Riverside Energy Park

Statement of Common Ground: Environment Agency

8.01.03

May 2019 | Revision 0 (Deadline 2)

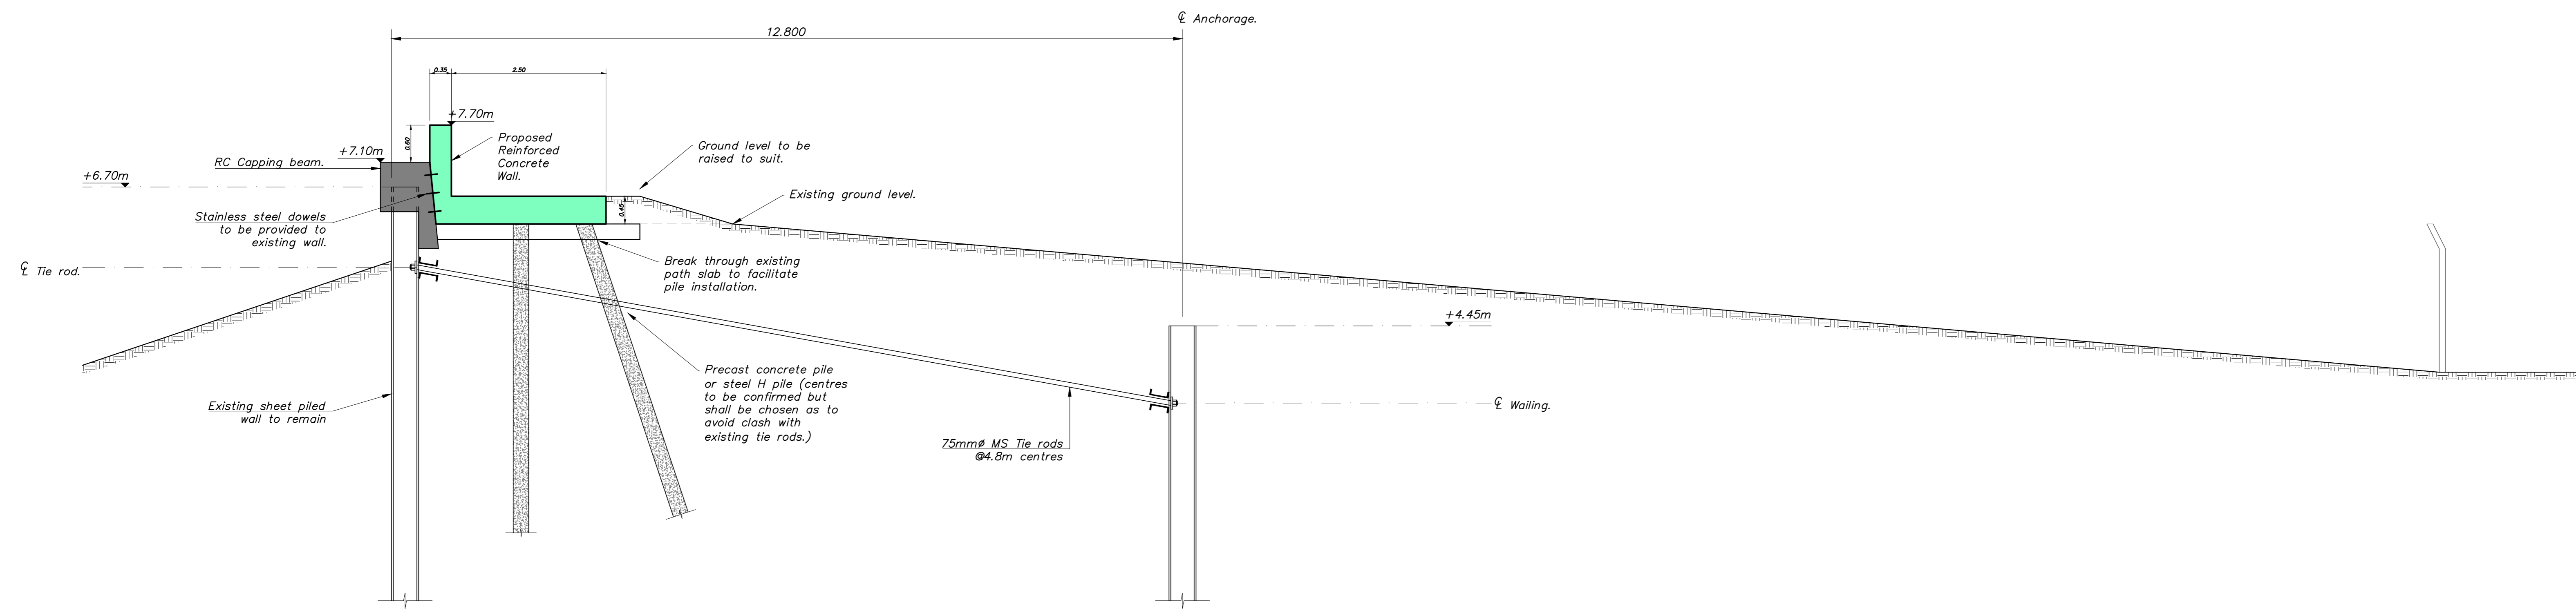
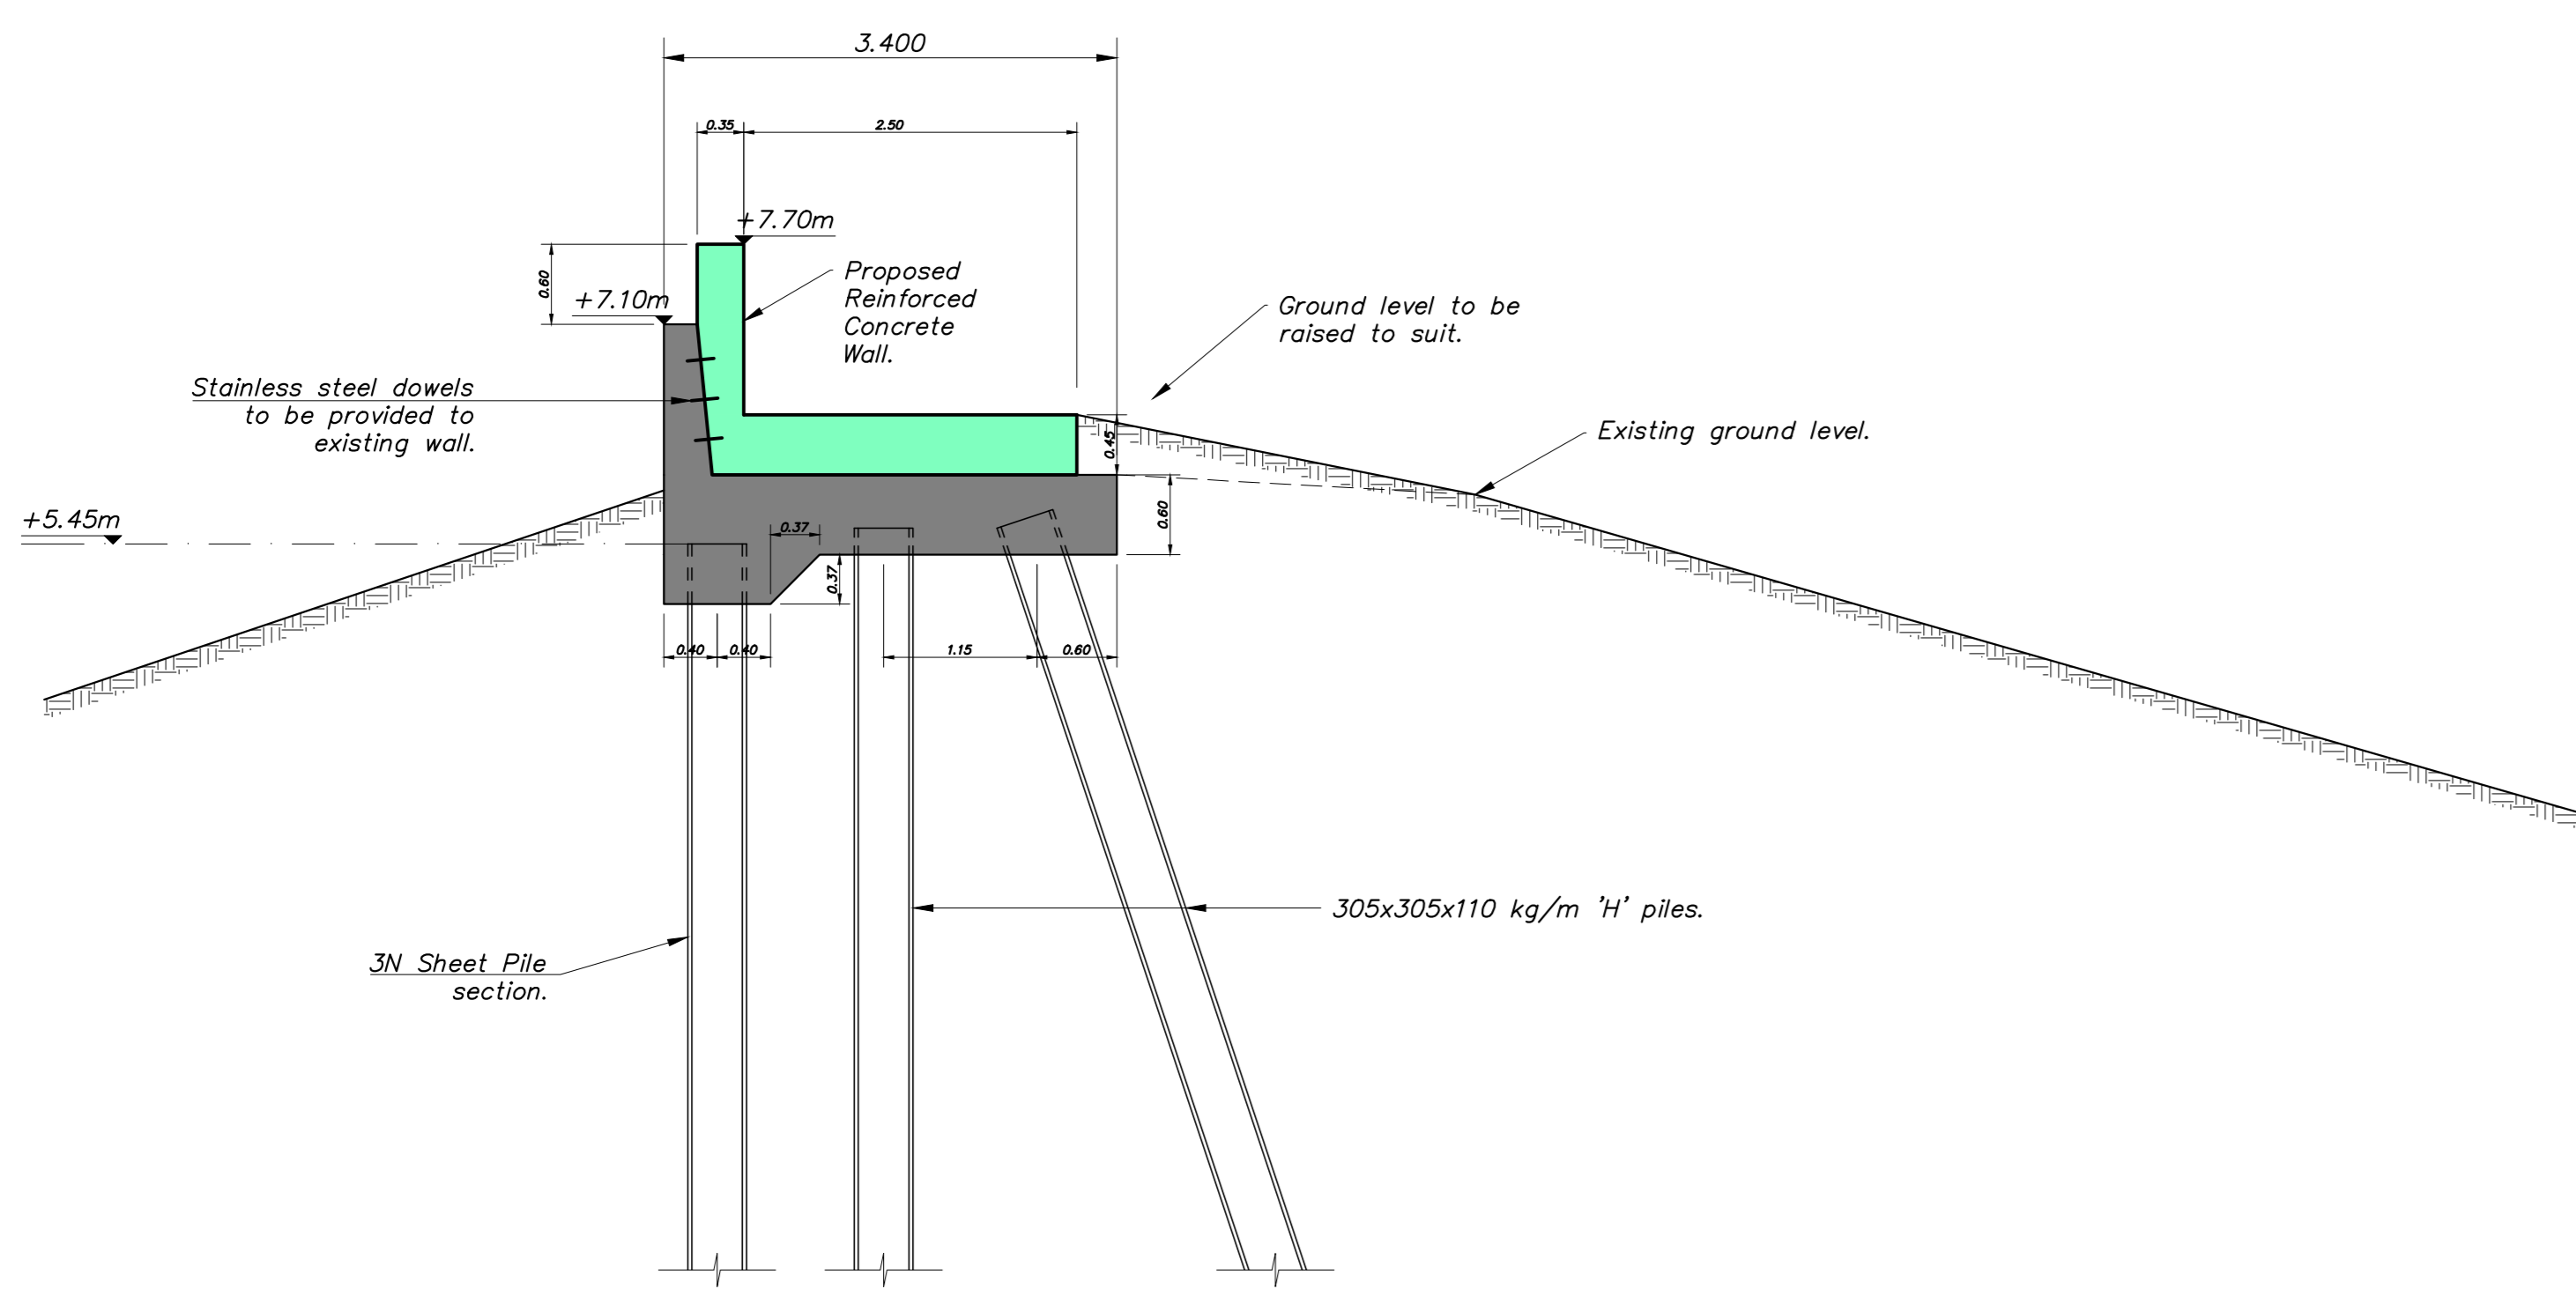
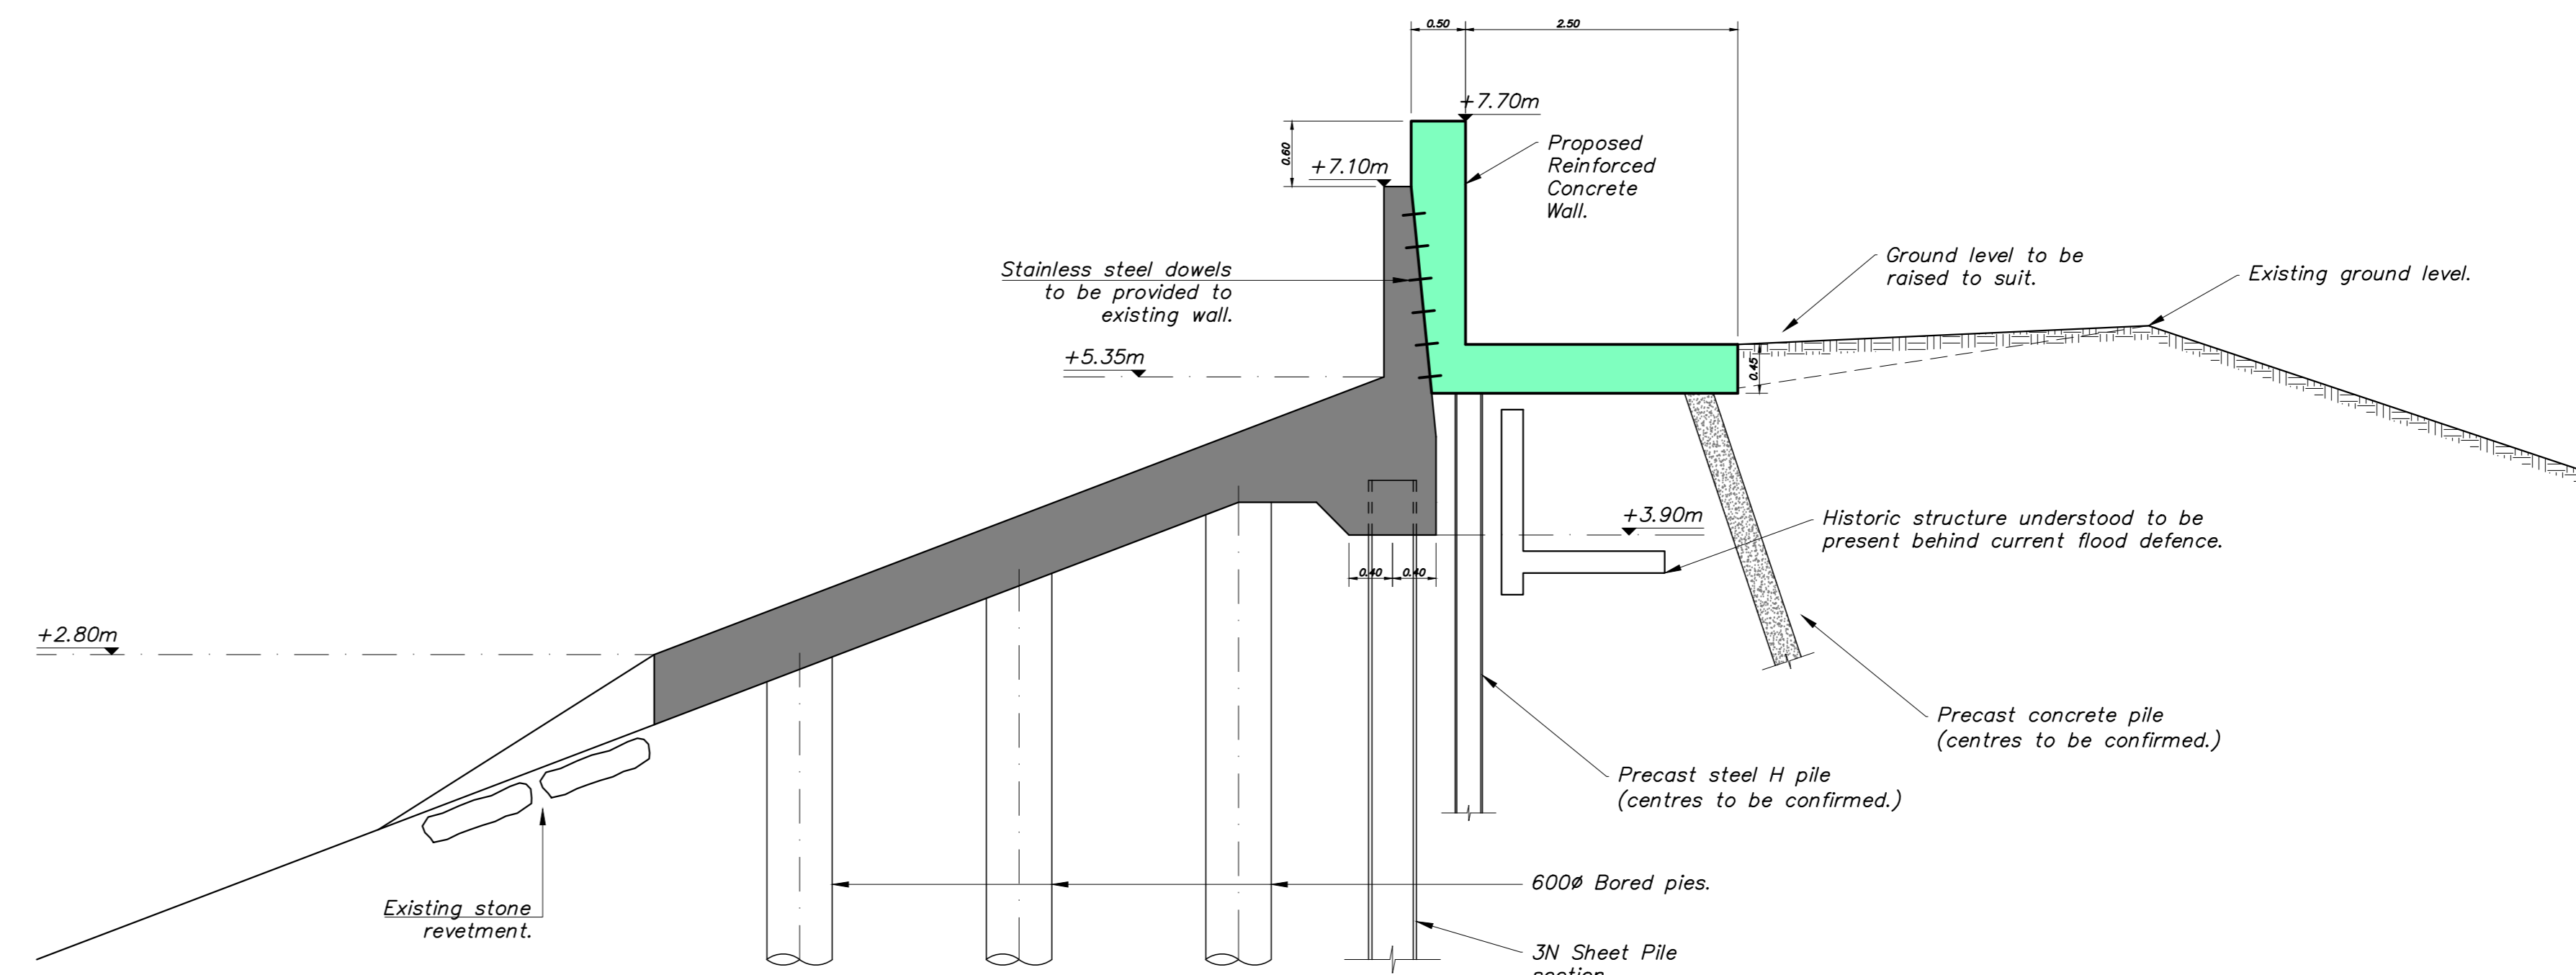
2.2.1 Through the indicative diagrams C110-113 (appended to this SOCG), the Parties agree that it has been demonstrated that the Proposed Development does not preclude the raising of the flood defence to the second stage level (of 7.7m AOD expected in 2070) proposed in the Thames Estuary 2100 Plan, and does not significantly restrict future defence raising options. These illustrative drawings were provided at the request of the EA in order to provide examples of technical solutions that could be adopted in the future should the need ever arise to raise the flood bank in line with the requirements of the Thames Estuary 2100 Plan.
